Addendum 21: UN Regulation No. 22

Revision 5 – Amendment 2

Supplement 2 to the 06 series of amendments - Date of entry into force: 4 January 2023

Uniform provisions concerning the approval of protective helmets and their visors for drivers and passengers of motor cycles and mopeds

"Annex 2A

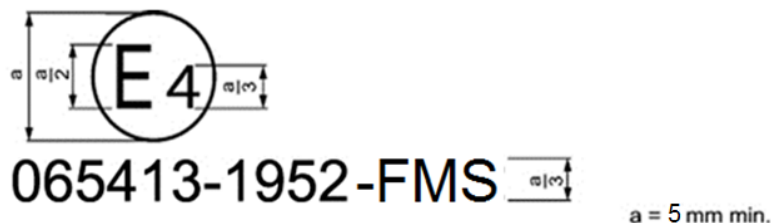
Annex 2A, amend to read:

The above approval mark affixed to a protective helmet shows that the helmet type concerned has been approved in the Netherlands (E 4) under approval number 061406.

The approval number shows that this approval concerns a helmet which has a lower face protective cover (P) and was granted in accordance with the requirements of UN Regulation No. 22 already incorporating the 06 series of amendments at the time of approval, that it can be fitted with a universal accessory having speakers and mounted in the front or in the side of the helmet and that its production serial number is 1952,

"Figure 1d
Example of a helmet simulator for accessories projections and surface friction
(method B)

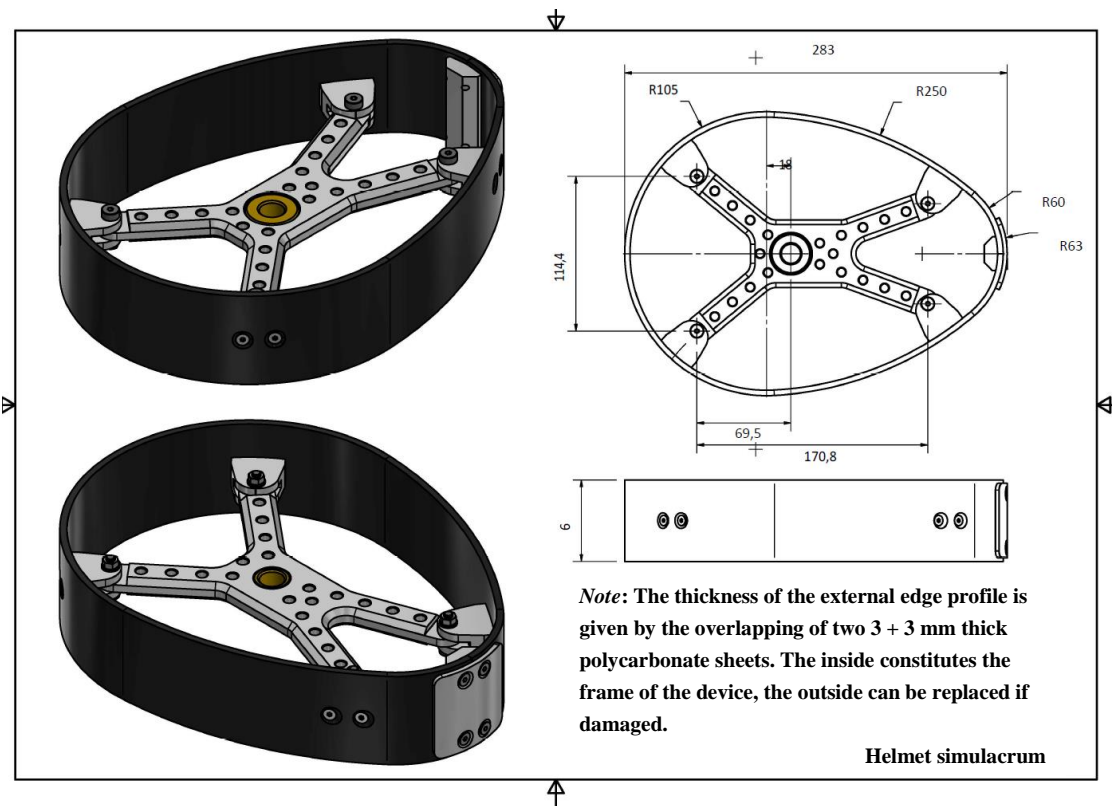
Annex 8, insert new figure 1d, to read:

Figure 1

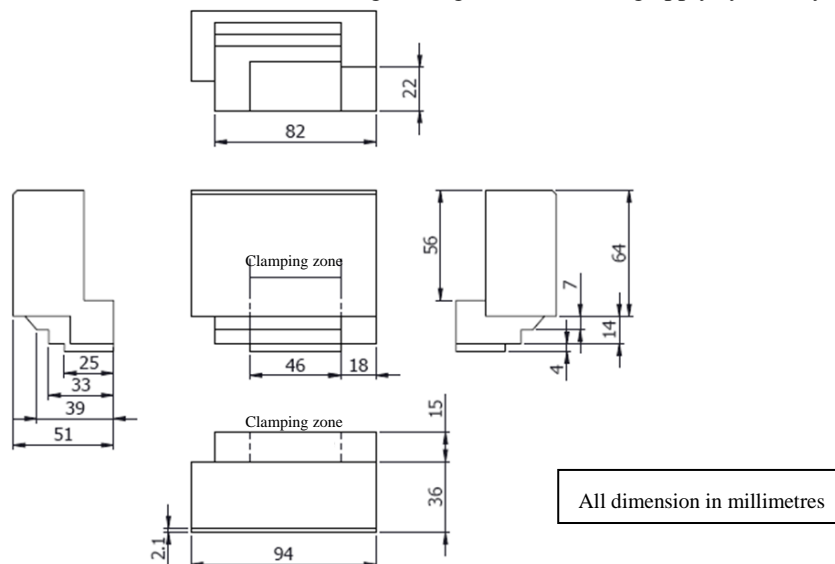
1.1.1. For front mounted accessories:

Fixture for left front- side mounting (for right side mounting apply symmetry)

Figure 3

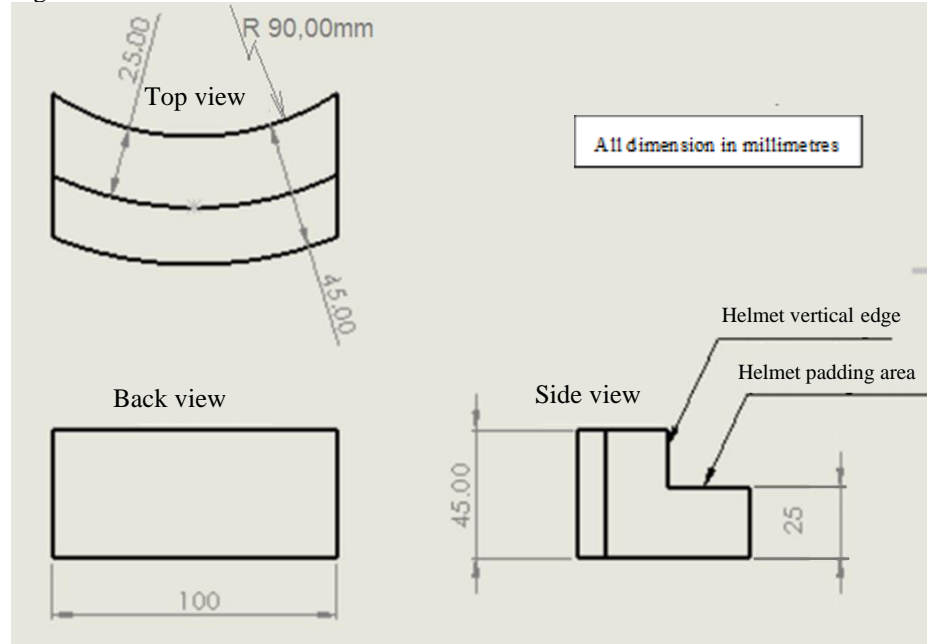
The rear mounting clamping solution offered by the accessory manufacturer will not invade the impact-affected area unless it fulfils the provisions laid down in this Regulation for those parts entering into the impact affected areas.

Figure 5
Speaker simulator

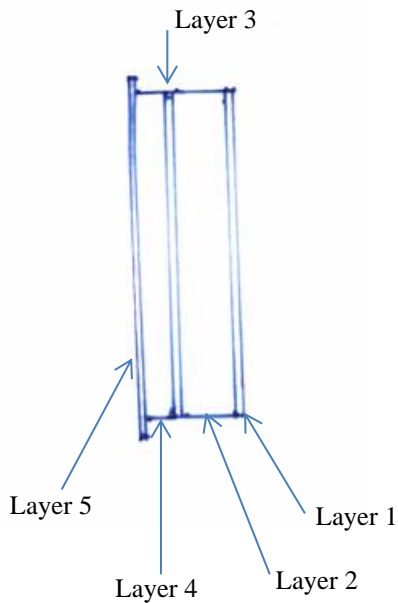
The speaker simulator is illustrated in Figure 5 of this annex. The dimensions of the individual components of the speaker simulator are listed separately below. The below layers are a possible construction methodology, alternative possibilities are valid provided that they will fulfil the requirements of 1.4.1.3.

- Diameter: 40 mm/45 mm
- Tolerance: +0-1 mm
- Thickness: 1 mm \pm 0.07 mm
- Material: Aluminium 5251/5052 (ISO 209, part 1)
- 1.4.1.1.6. Adhesive
- The adhesive to be used throughout should be a two-part polyurethane (such as Ciba-Geigy XB5090/1 resin with XB5304 hardener, or equivalent).

Figure 7

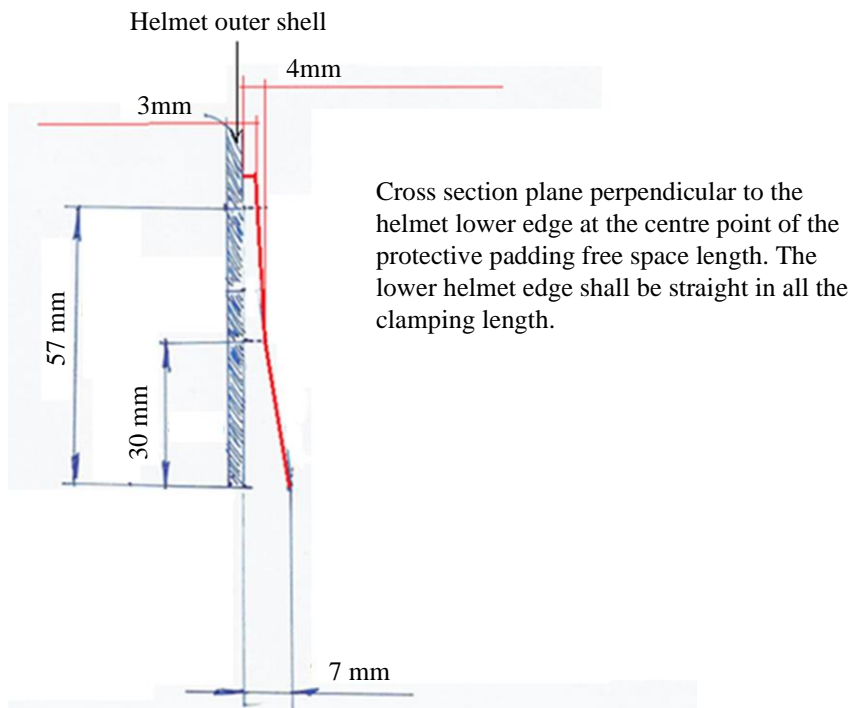
- 2.1. The helmet clamping free space dimensions for front and side mounting will be, at least, the following ones:

Free protective padding space for accessories clamping for front and side locations of UA helmets

The length of clamping zone will be according to the fixture drawings.
